Plan Holders of: **GRETCHEN TALLEY PARK – PHASE III IMPROVEMENTS
1551 DOVE DRIVE, TRACY, CA – CIP NO. 78170**

Subject: Addendum No. 2

ADDENDUM NO. 2

SHEET
C2.2

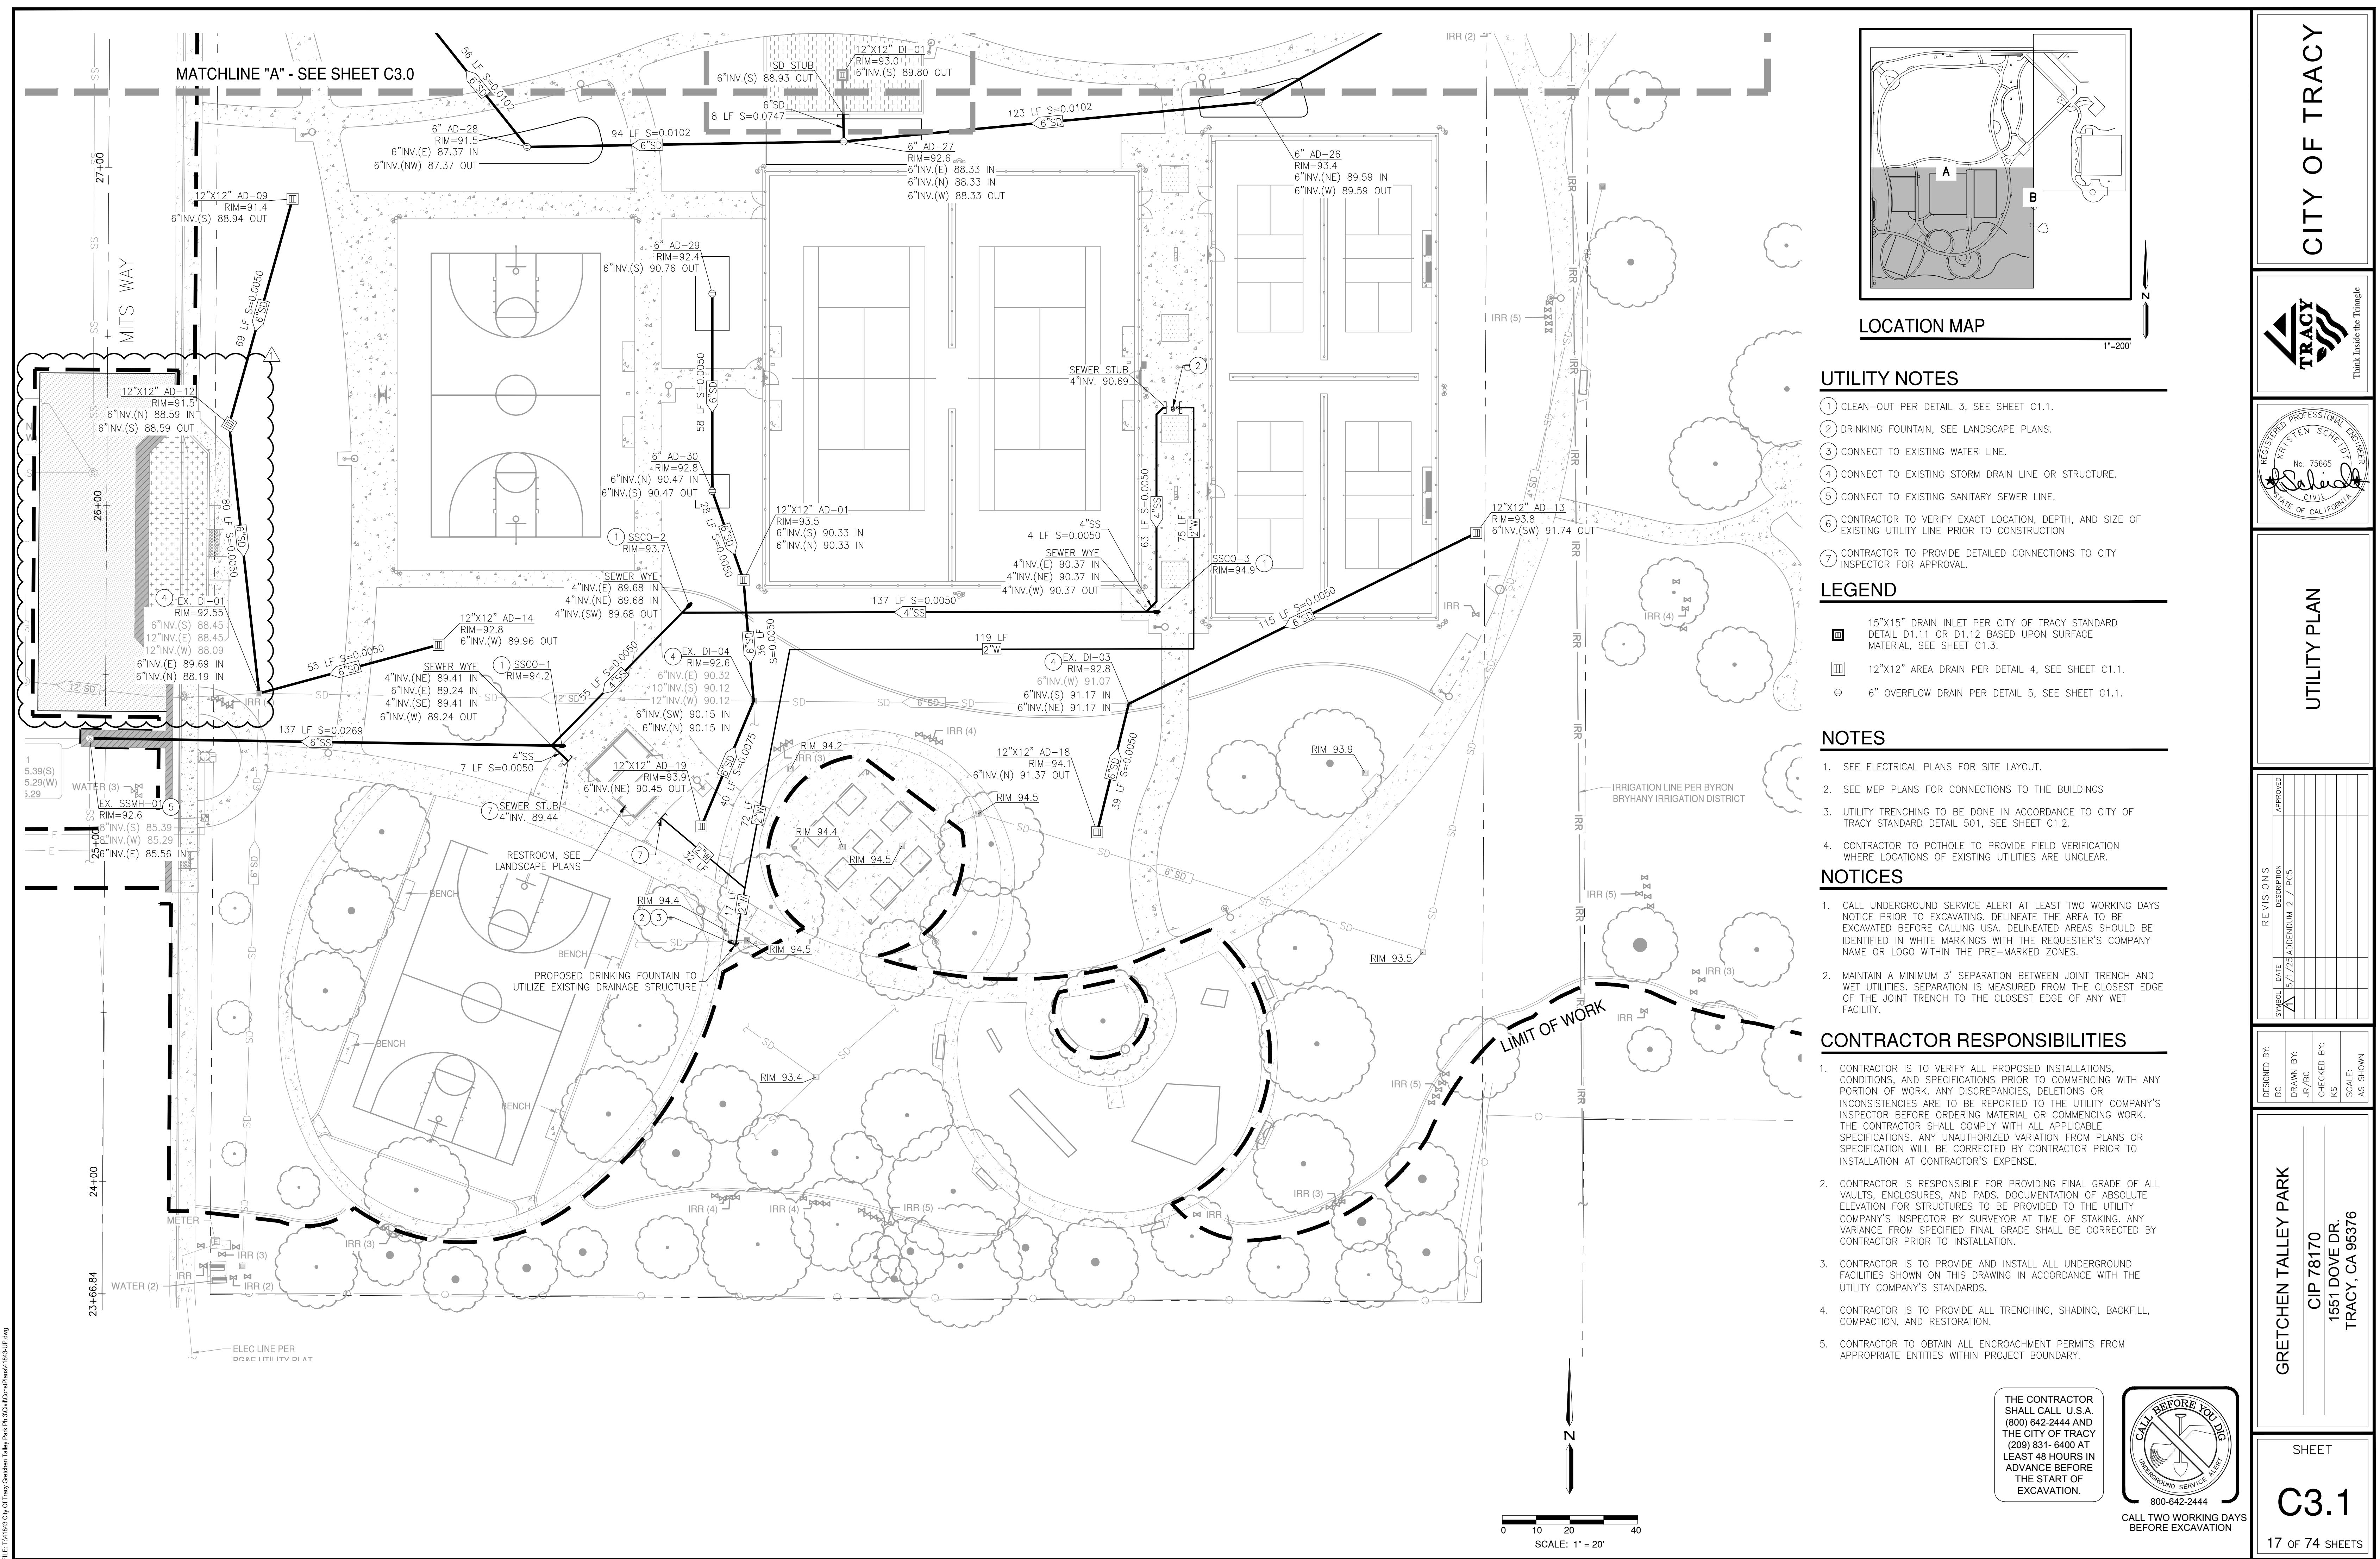
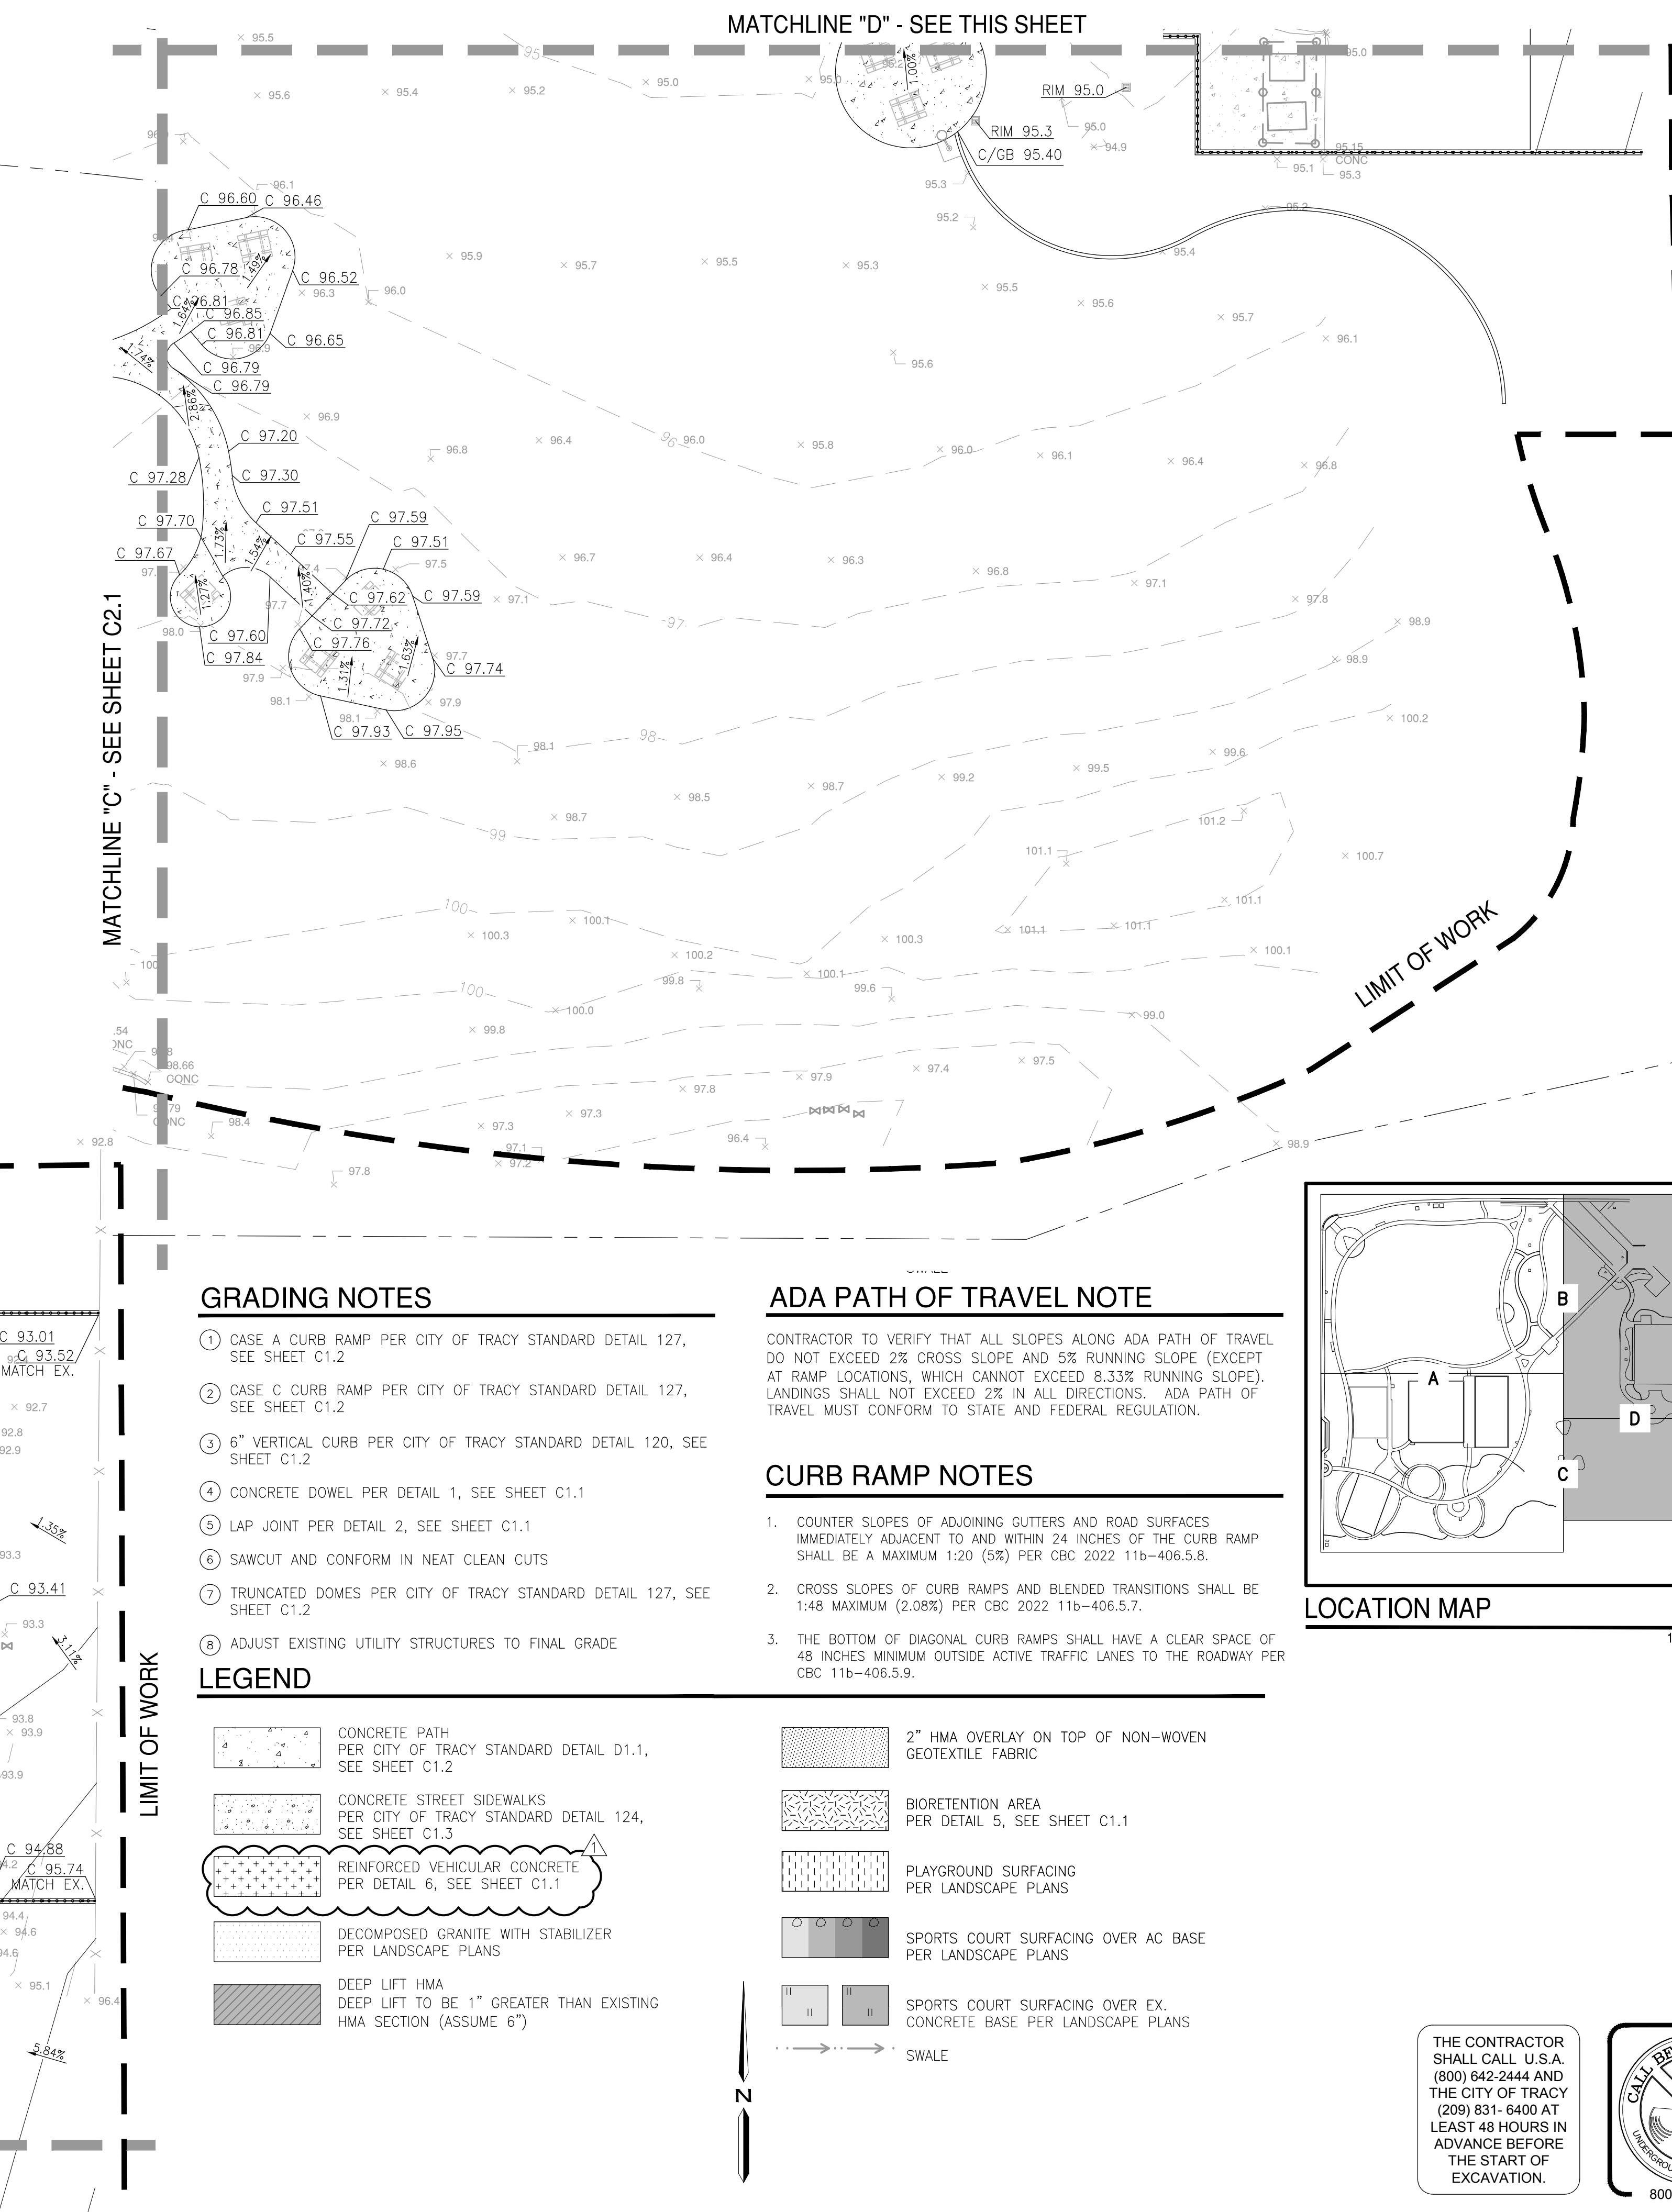
Item No. 1	L2.0 – Additional sawcut and removal with grinding in specified locations and modifications to demolition legend.
Item No. 2	C1.0 – Revisions to Sewer and Water Pipe Materials.
Item No. 3	C1.1 – Addition of accessible parking zone section, modification of callout on Detail 3.
Item No. 4	C2.0 – Modification to legend.
Item No. 5	C2.1 – Modification of accessible parking and addition of grinding and overlay and modification to legend.
Item No. 6	C2.2 – Addition of cleanout rim elevations and modification to legend
